BOARD OF ADJUSTMENT MEETING CITY OF ST. PETE BEACH

Wednesday, October 26, 2022
2:00 PM

1. Approval of the Agenda -
2. Audience Comments - **Comments shall be limited to 3 minutes per person**
3. Approval of Minutes
 - a. Minutes from August 31, 2022
4. Action Items
 - a. Approval/Acceptance of 2023 Board Meeting Dates
 - b. **Variance, Practical Difficulty - 638 70th Ave. (Case No. 22038)**

PROPOSED FRONT ELEVATION

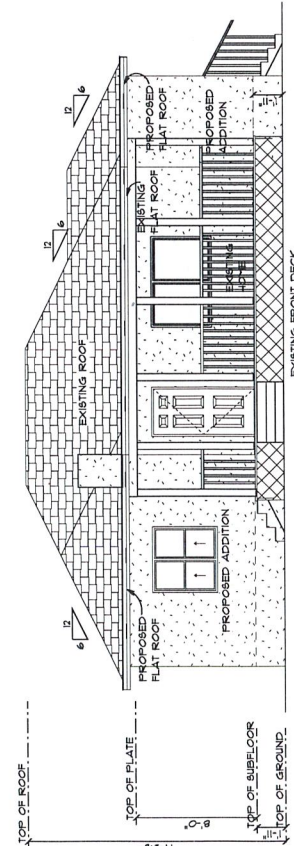
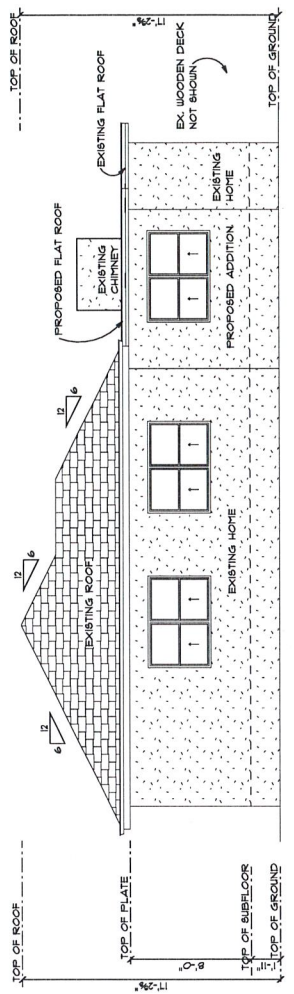
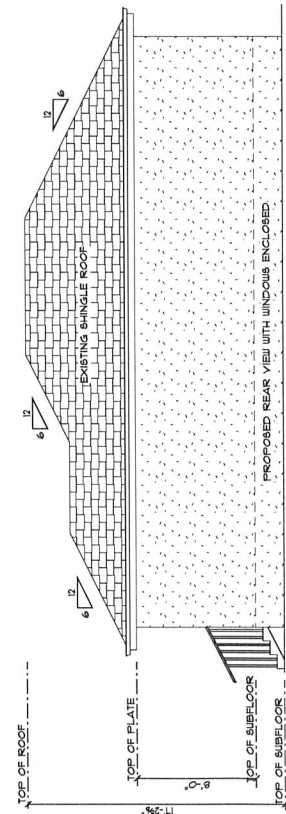
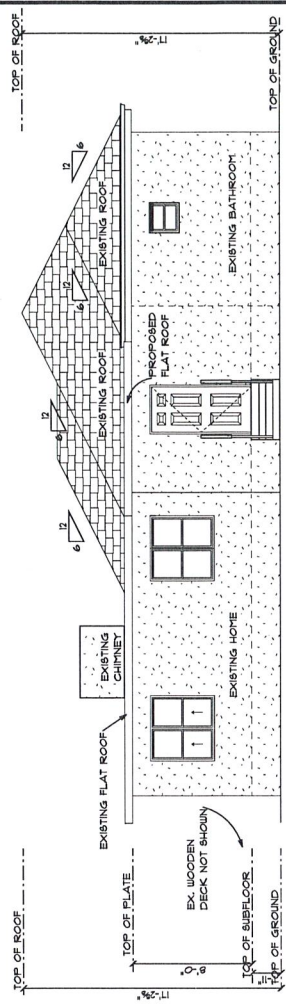
4. No information was provided with regards to the height(s) of the proposed additions and should be indicated on the application.

- The Proposed Elevations are attached to show the proposed addition with flat roof to match with existing flat roof in the living area.

PROPOSED SITEPLAN

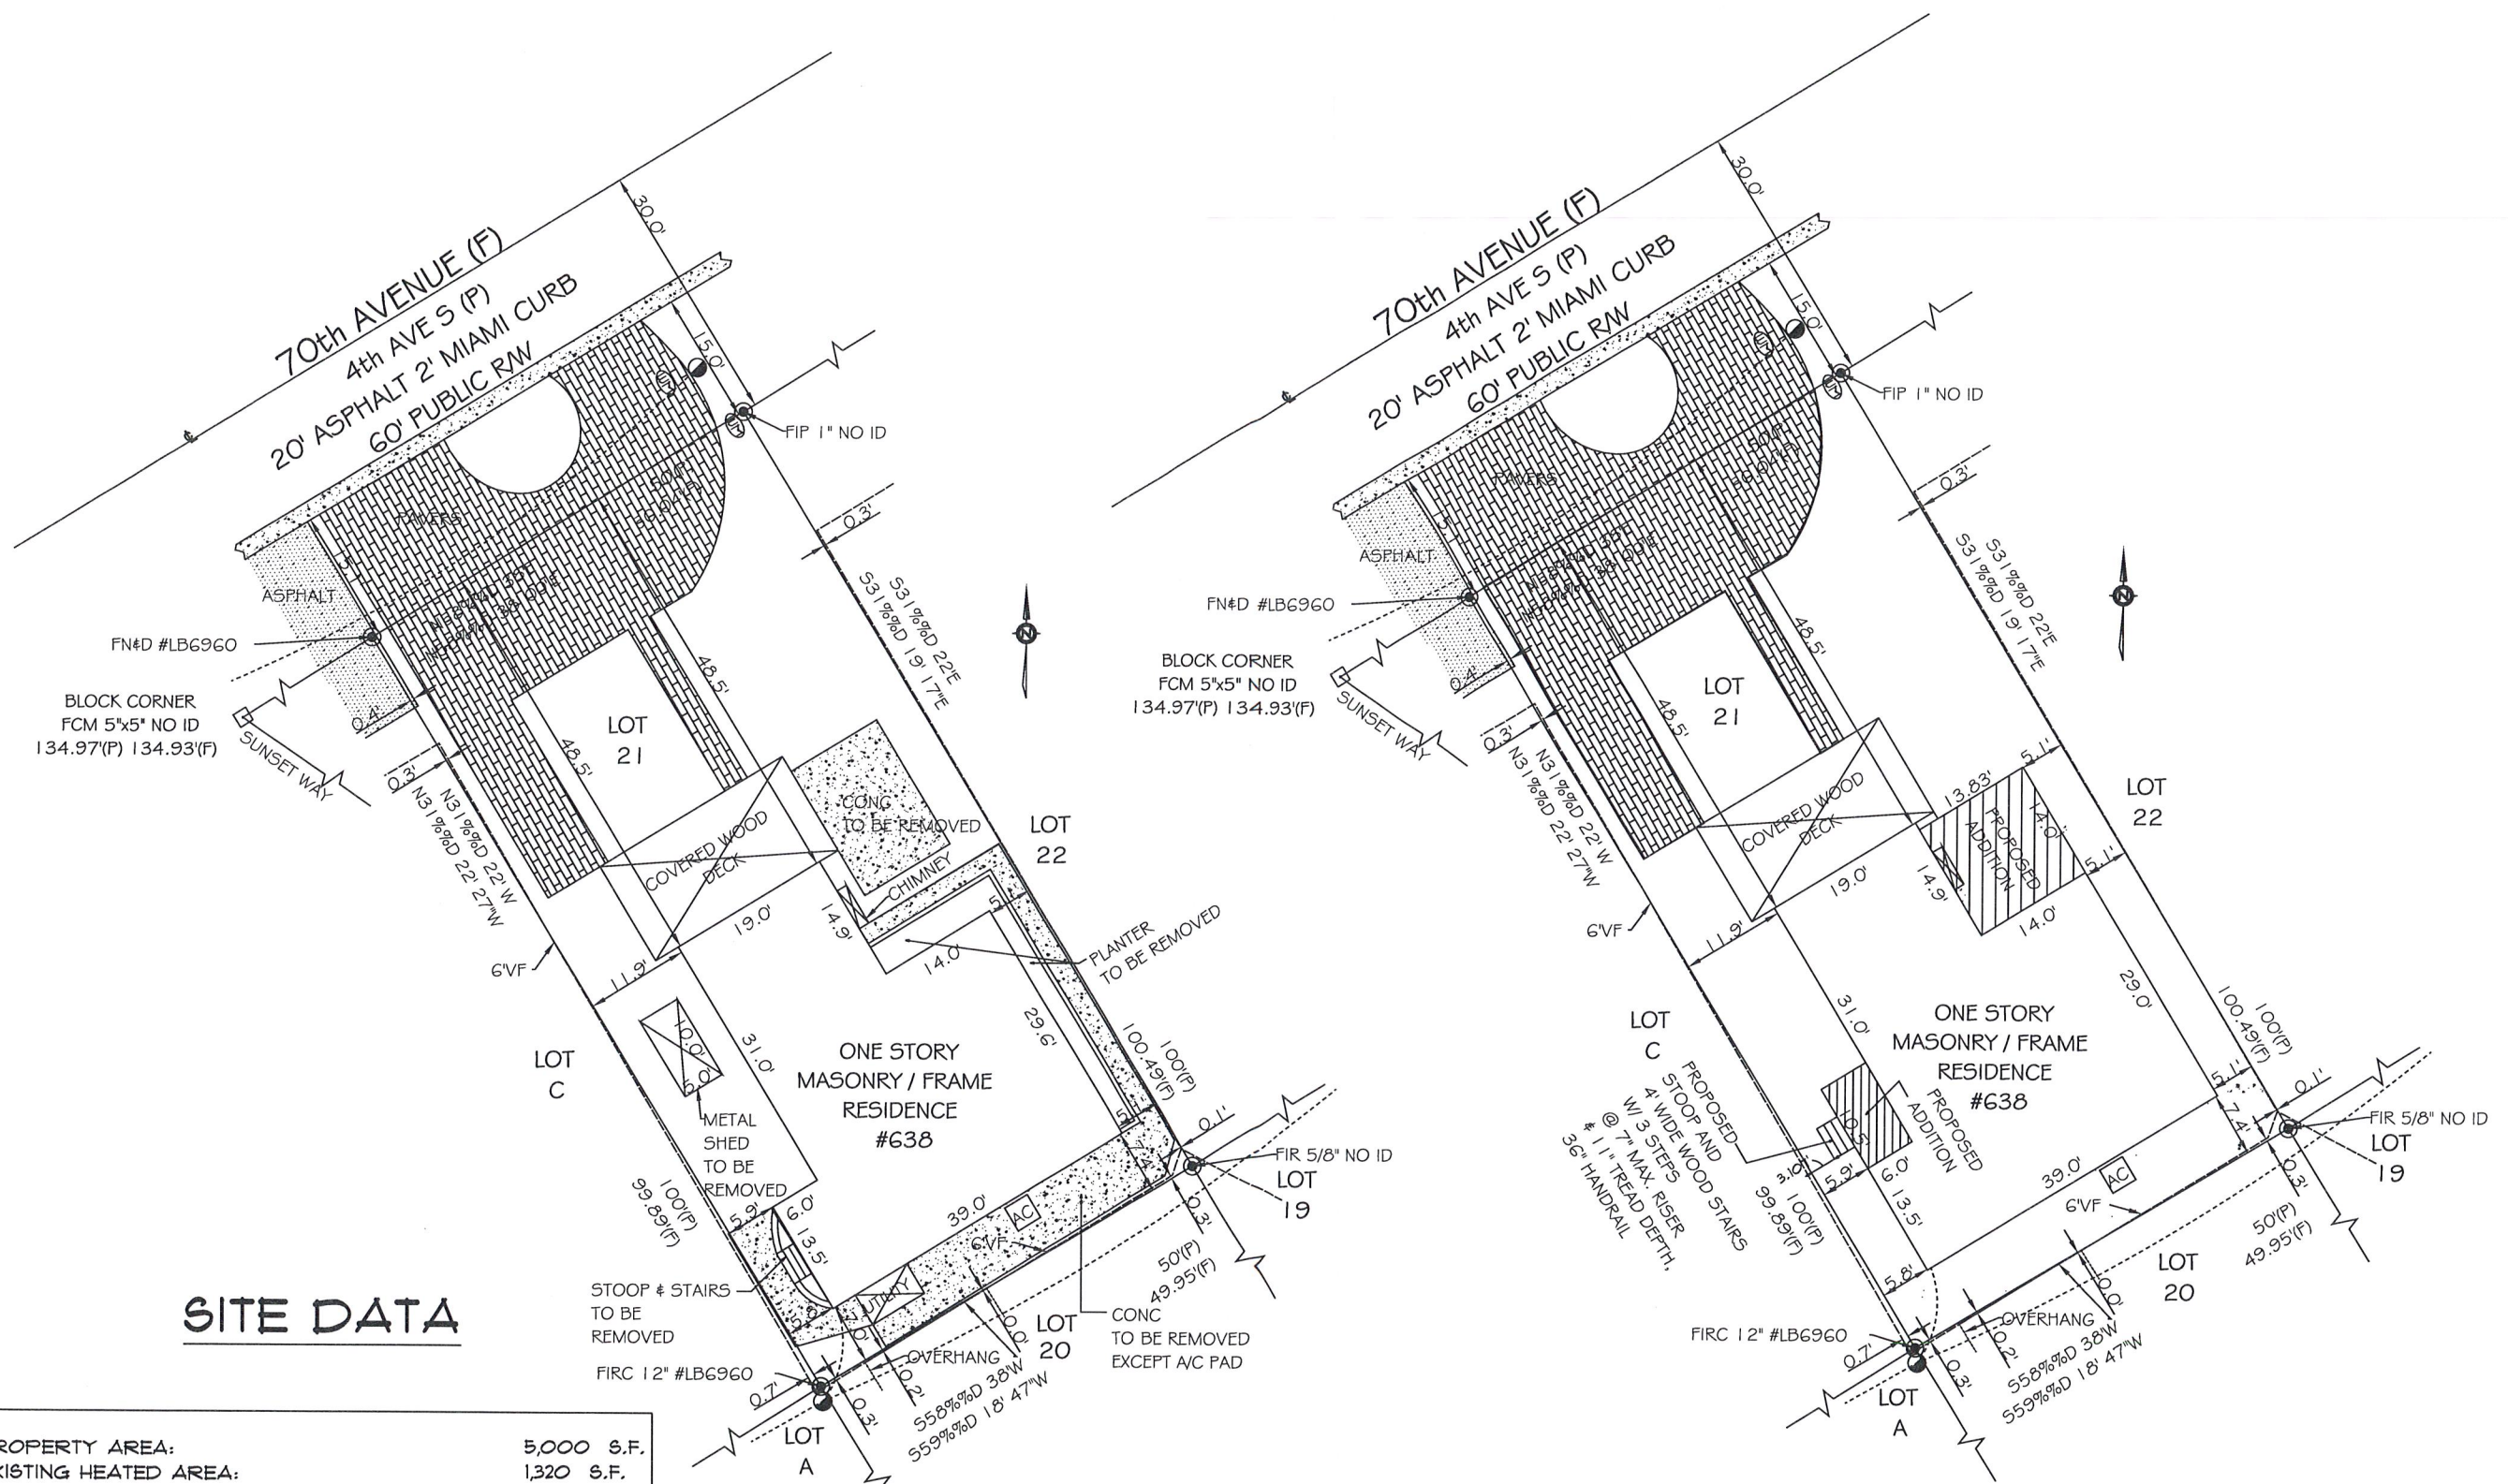
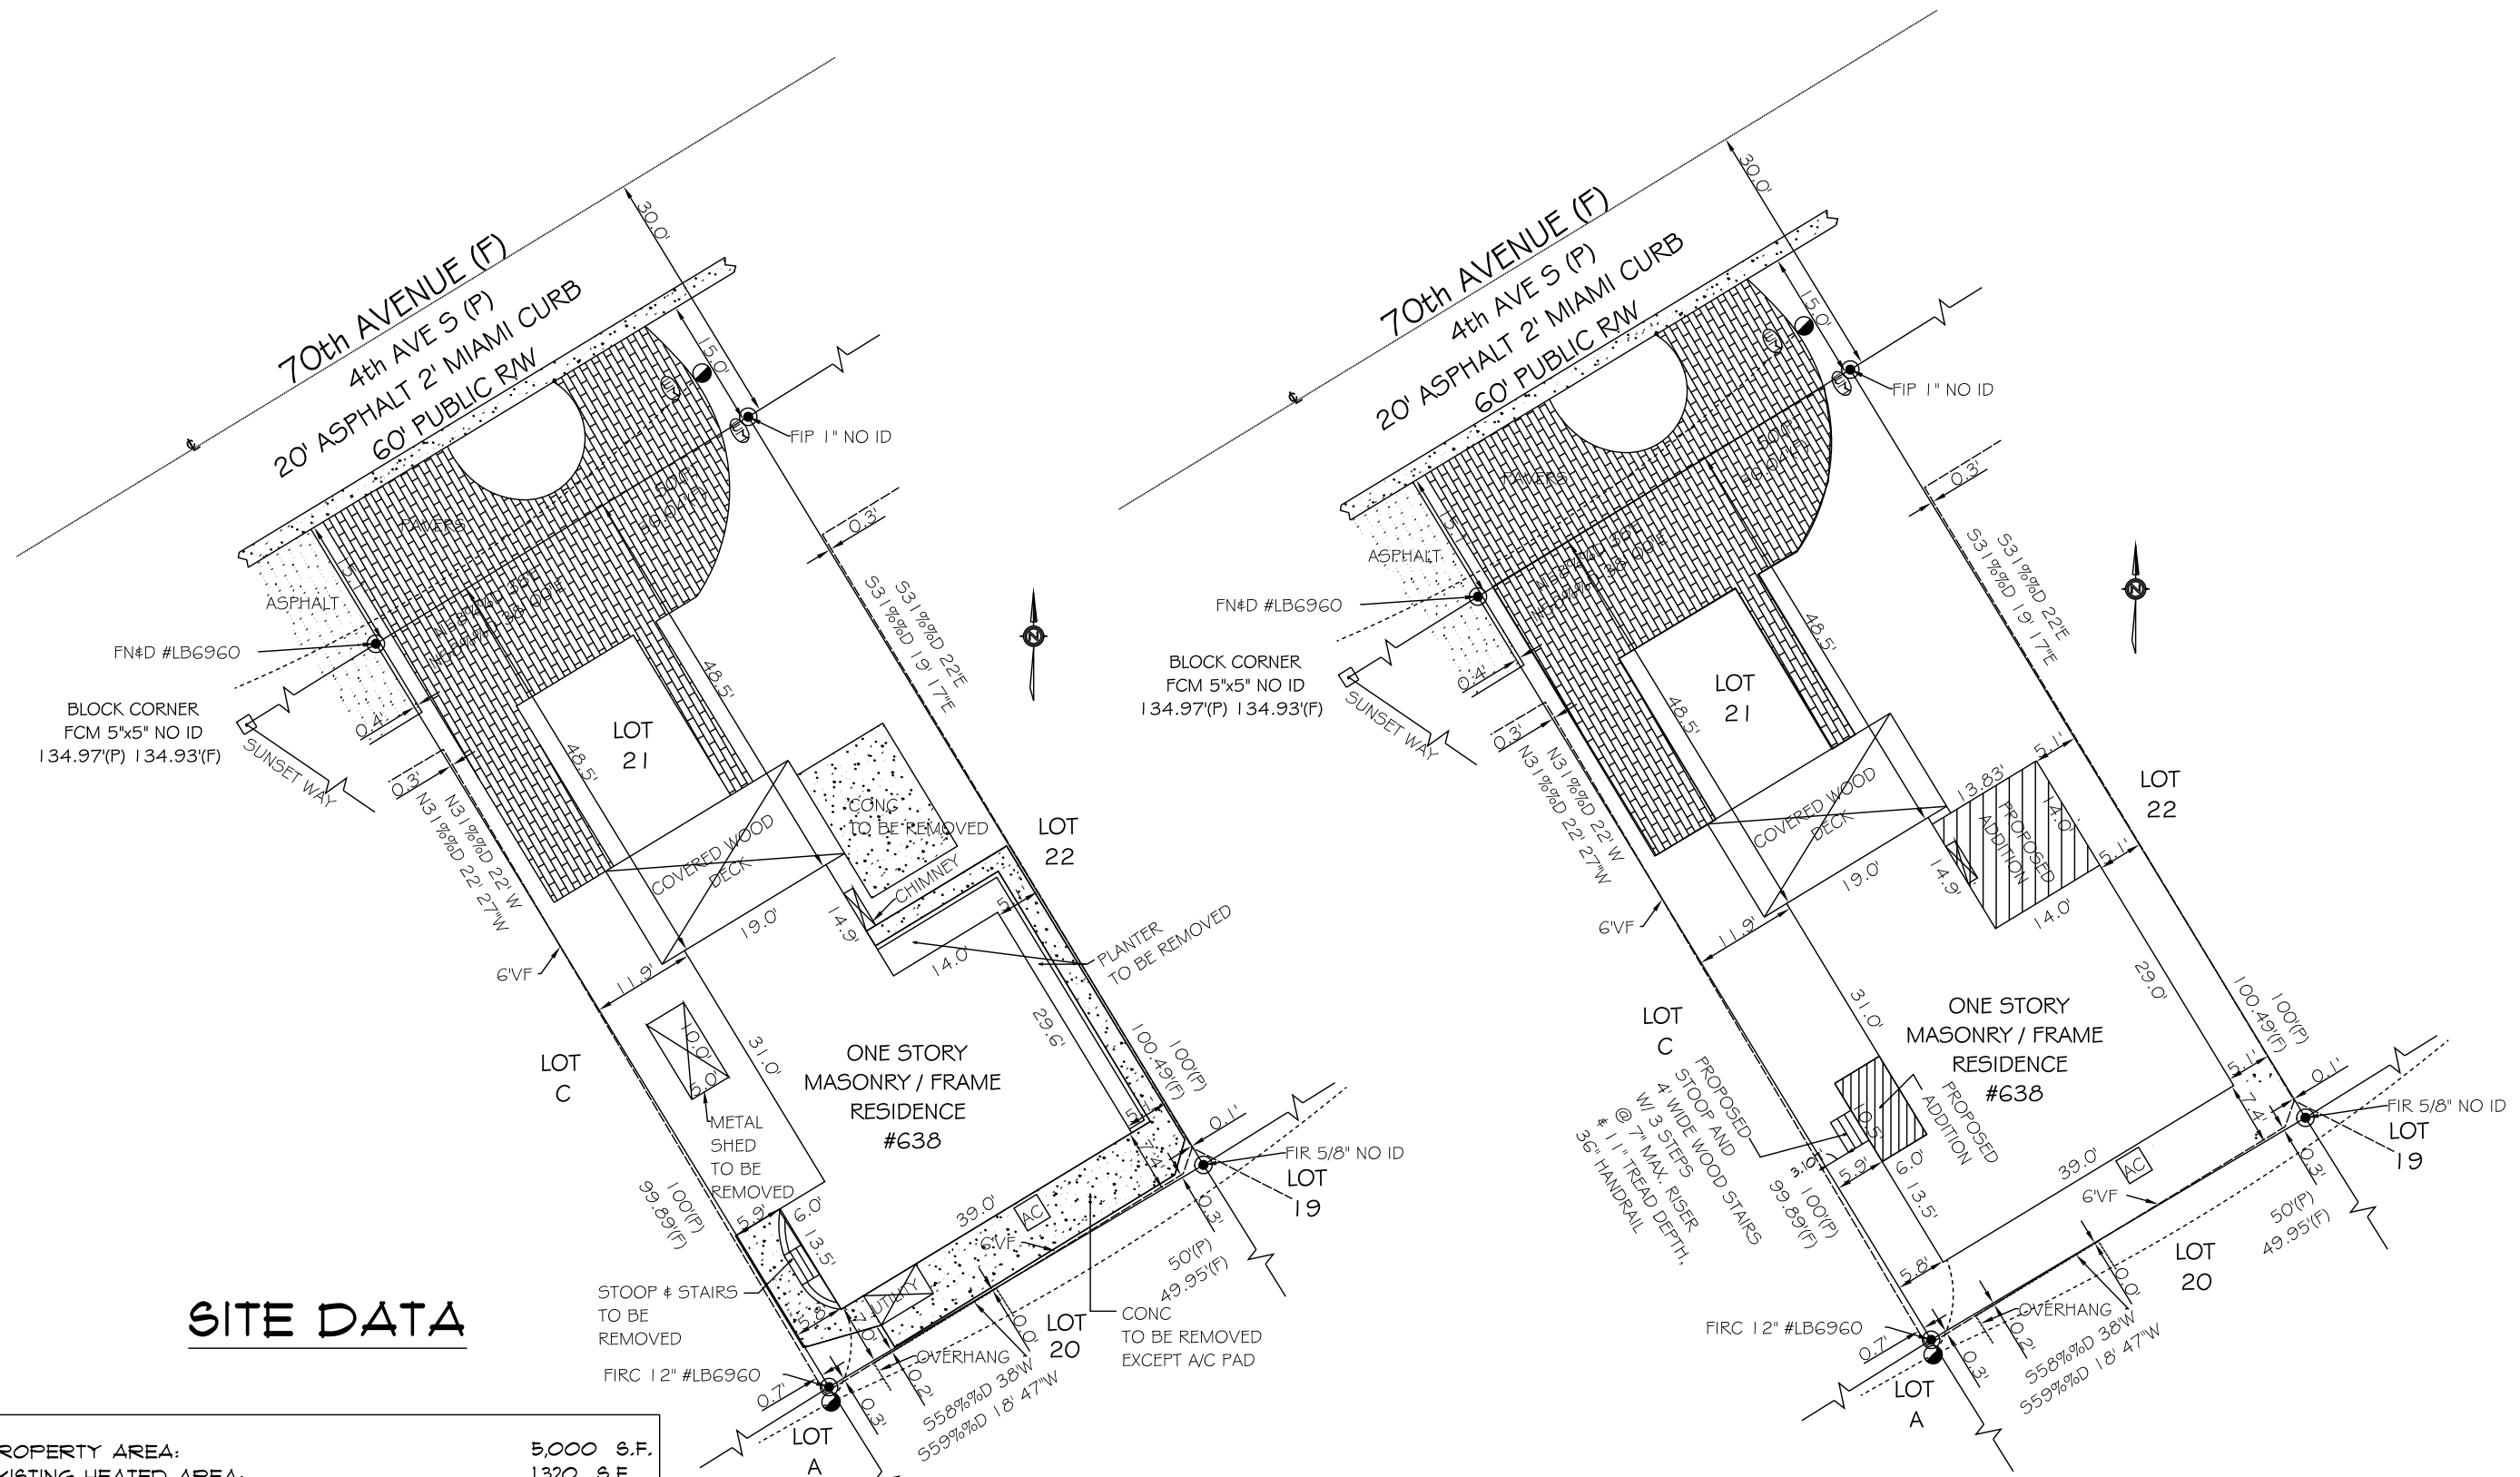
1. The survey submitted indicates substantial portions of existing concrete to be removed (T.B.R.) which includes the existing stoop and stairs on the western property line. The floor plan shows relocation or installation of a new door along the western property line, but no details were provided on the survey showing the dimensions of a stoop and stairs to allow access from the new location of the door. This is needed to verify compliance with code.

2. Detail should be provided on the concrete area to remain surrounding the existing AC unit. Any areas that are to remain should be noted to scale on the survey and dimensions indicated.

3. Dimensions shown on the survey submitted indicate the interior measurements of the additions, and do not match the exterior dimensions as shown on the floor plan and should be amended to be consistent.

- Please see updated Proposed Site Plan for the stair with dimensions.

- Please see table added to Proposed Site Plan for the impervious area for the parcel.

- Please see amended dimensions on the Proposed Site Plan to match the Floorplan measurements.

Figure 5: Survey with proposed structure (N.T.S.)

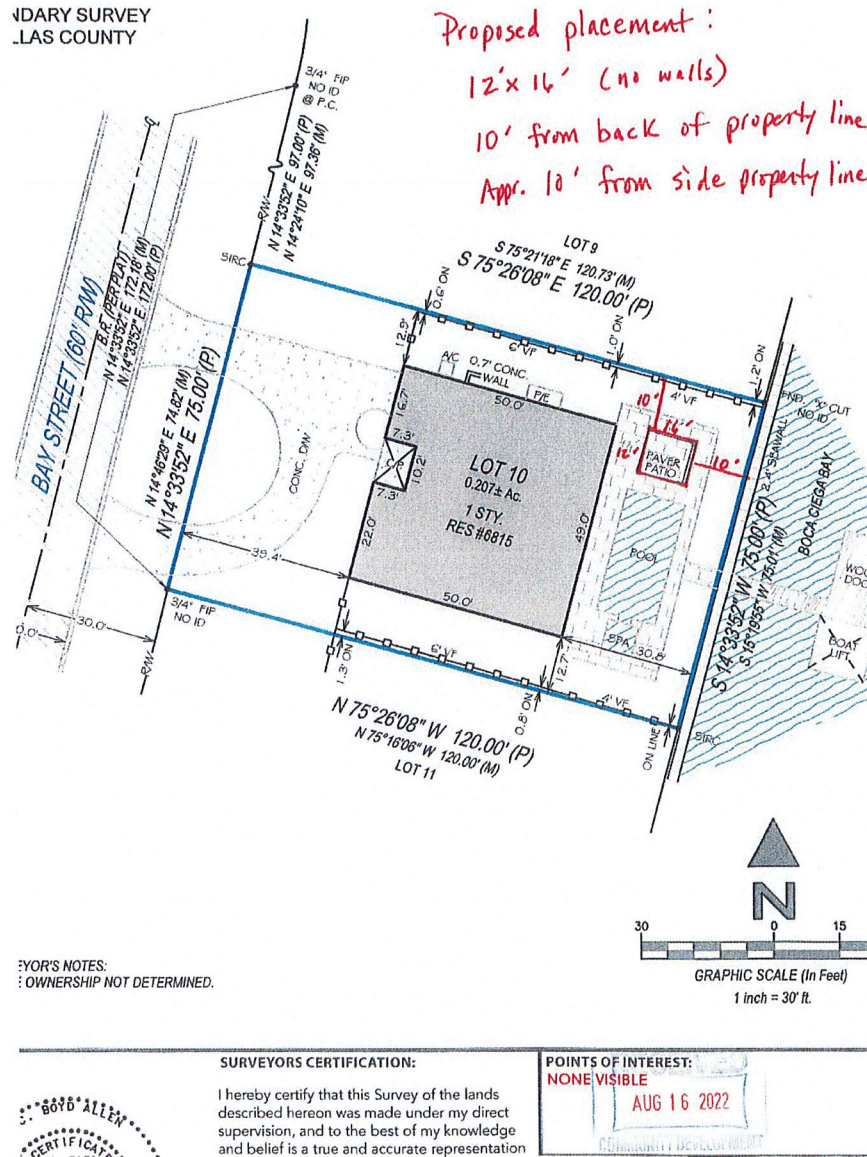
It should be noted that the Land Development Code does not specifically address this type of proposed structure within Section 6.13-Residential accessory structures. The applicant had applied for zoning approval and was denied when applying section 6.13(c)(4)-Gazebos.

Staff finds no adverse change will be produced in the character of the neighborhood. The proposed structure is to contain open sides and will allow the adjacent neighbors to maintain an open line of sight of views.

- Construction drawings submitted show the sides of the structure to be open. Applicant should advise if there are any plans to enclose the structure at a future date.

Figure 5: Survey with proposed structure (N.T.S.)

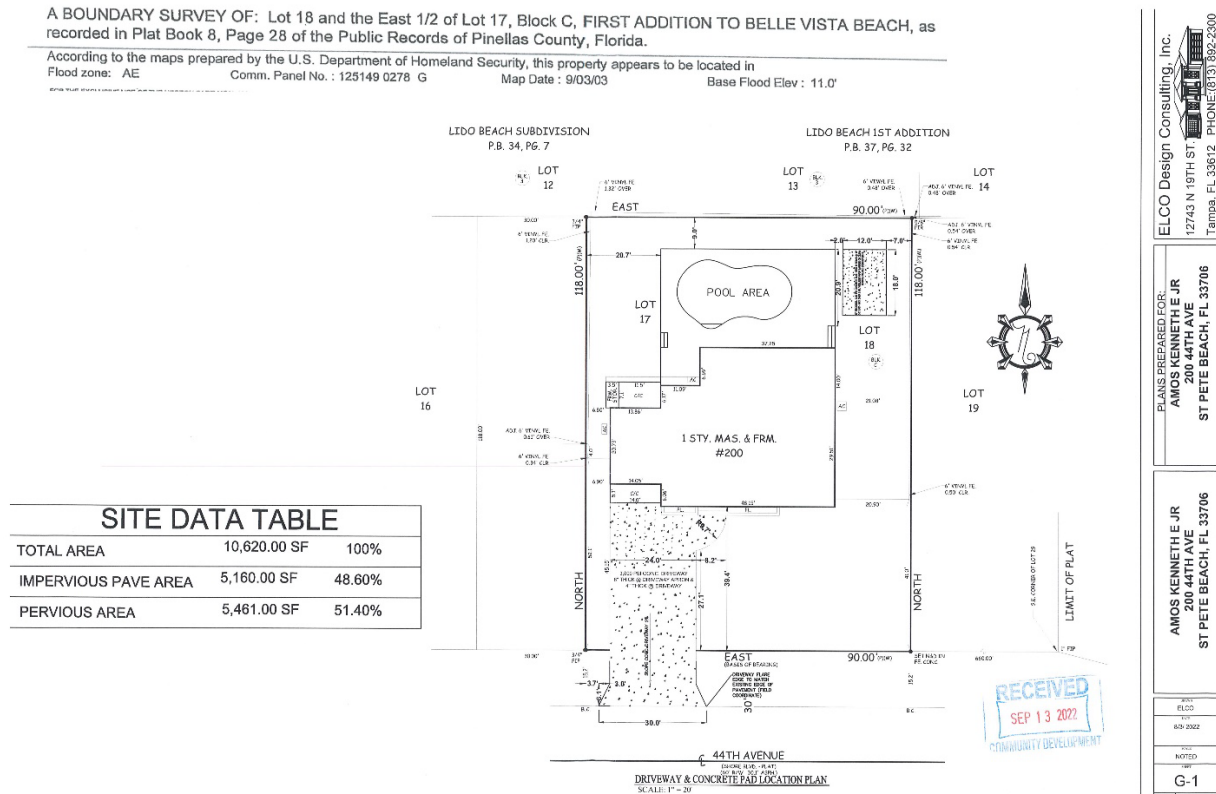
Staff finds no adverse change will be produced in the character of the neighborhood. The proposed storage building while oversized, would be screened from adjacent properties by an existing 6' high fence.

- Applicant should provide testimony as to the materials to be stored on or within building.
- Information should be provided on any proposed installation of landscaping around the foundation to visually screen the excess height of the building.
- Applicant should provide testimony as to how the stormwater runoff shall be directed and maintained on the property to ensure compliance with LDC Sec. 6.13(b)(3).
- Applicant should provide explanation for the proposed 2' separation from the elevated patio to the building location and if access to the building is intended from the patio.
